City of Bothell™

Canyon Park Subarea Plan Update

Draft Environmental Impact
Statement comments received on or
before January 13, 2020.

Figure 1. Canyon Park Study Area

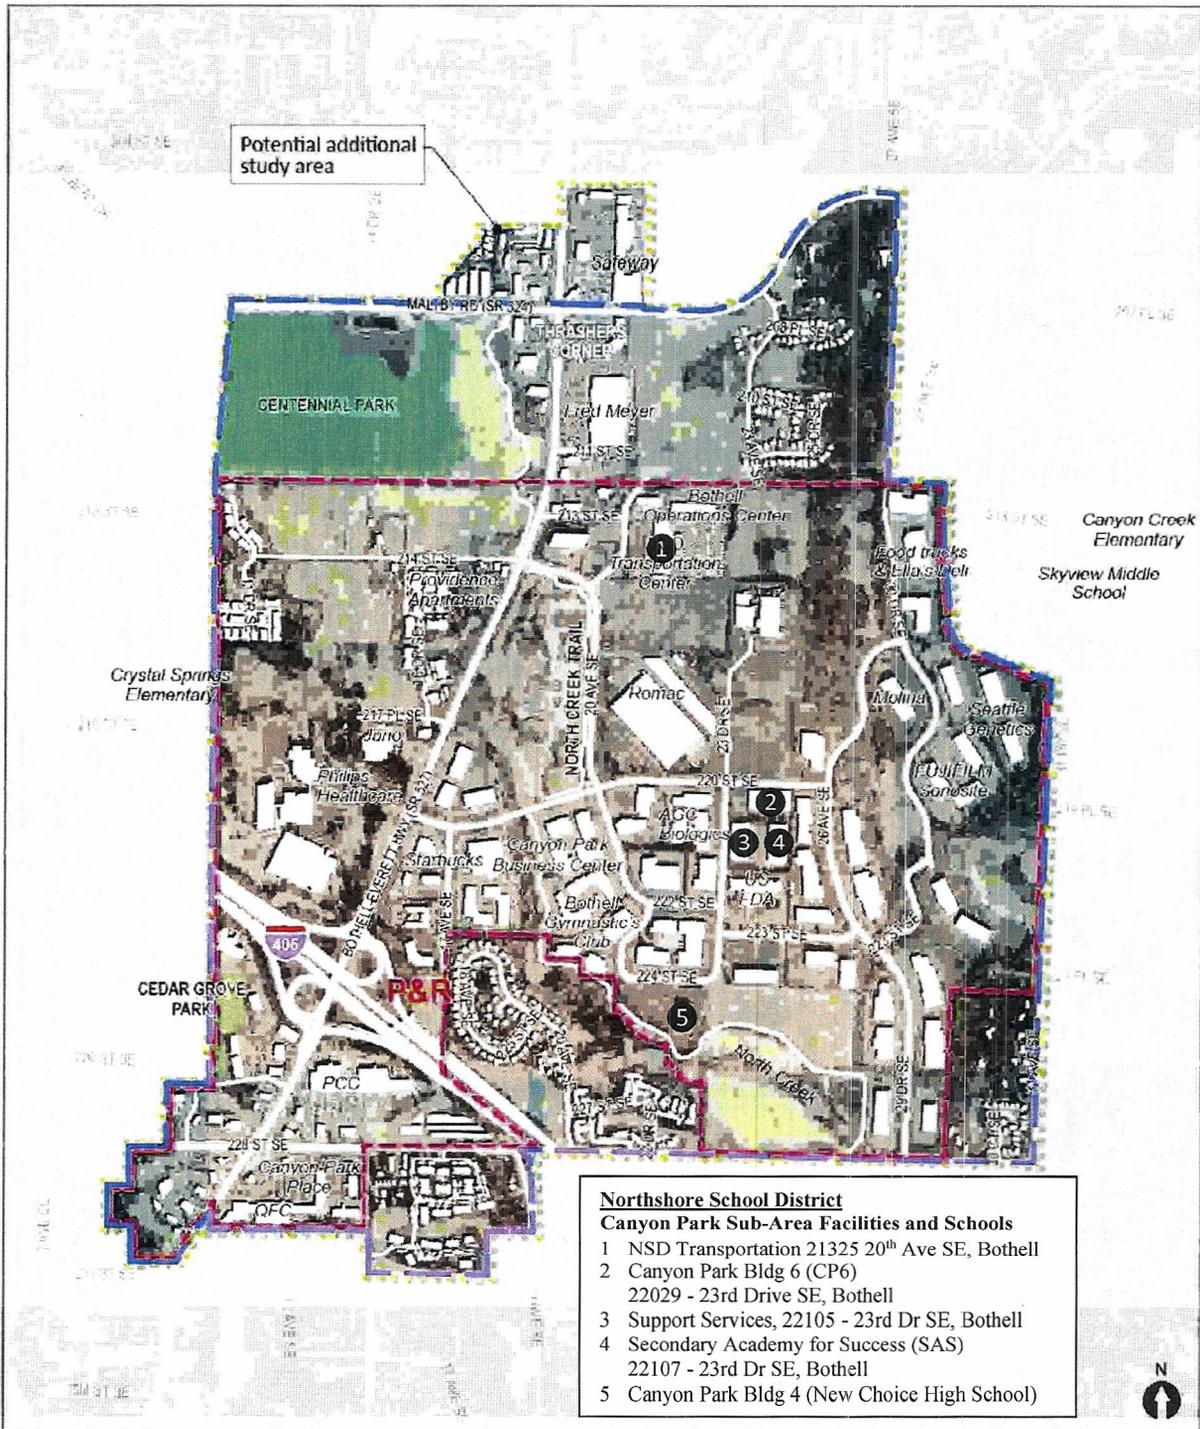
I represent the Northshore School District (District) and this letter provides comments from the District on the Canyon Park Subarea Planned Action Draft EIS (DEIS). This letter represents general comments and the District looks forward to discussing the DEIS further with City staff. The District has significant capital holdings in the subarea that need to be discussed in more detail as it relates to future growth, additional housing and potential transportation improvements.

Under *1.6 Objectives* of the DEIS, there is a statement about Canyon Park being a multifaceted neighborhood. The diverse mix of uses described does not include the District's significant capital facilities located within the subarea. District facilities include: the NSD Transportation Center, Support Services Center, Secondary Academy of Success (SAS), CP6 (Leased-out building and some District warehousing) and the recently acquired CP4, which will house a future Choice High School. The transportation facility was the only District facility mapped on *Figure 1. Canyon Park Study Area*. The attached graphic depicts the location of all District facilities within the subarea. These are critical facilities for the District and should be mentioned early within the document when characterizing uses within the subarea. This is also important when referencing the subarea as a Transportation Hub, since it does contain the transportation facility (busing and support vehicles) for districtwide school use.

The Summary does include a discussion of schools and does state that the elementary, middle and high schools serving the study area do not have enough permanent capacity to accommodate demand at any grade levels under both growth alternatives. Page 3-173 acknowledges additional facilities would be needed to accommodate student enrollment. While the growth would be incremental as individual projects develop, the impact has not fully been addressed in the DEIS. The City should develop a plan with the District on how growth and transportation impacts can be mitigated. On-going discussions with the District would be helpful so that all parties understand impacts and potential mitigation necessary to ensure school facilities are keeping up with demands.

On page 3-146 of the DEIS is a table with Project Map Descriptions for potential transportation improvement projects. The District's Transportation Department has concerns about the plan #16 and #17. Transportation has expressed a need for a roundabout at 214th St. SE and 20th Ave. SE. Westbound traffic at 5:00 PM is so backed up in the right lane that vehicles leave an open space so vehicles in the left lane can turn right onto 20th Ave. SE. Currently it is challenging for school buses to make a turn in or out on 20th Ave. SE during peak times. Opening up 20th Ave. SE to Maltby Rd. would create additional concerns. There are already a high number of collisions in that section of Maltby Rd. between SR-527 and east of the driveway into Willow Tree Apartments. Additional traffic in front of the NSD Transportation Center would increase time and costs to the District's transportation operation. Potential revisions to the 9th Ave. SE corridor would most likely impact Crystal Springs Elementary School. Any future pedestrian improvements must include at minimum raised 5-6' sidewalk/curb with a landscape barrier and bike lane for separation, signal controlled crosswalks (228th, 226th and 217th) and parent staging/parking on 9th Ave. SE in front of the school.
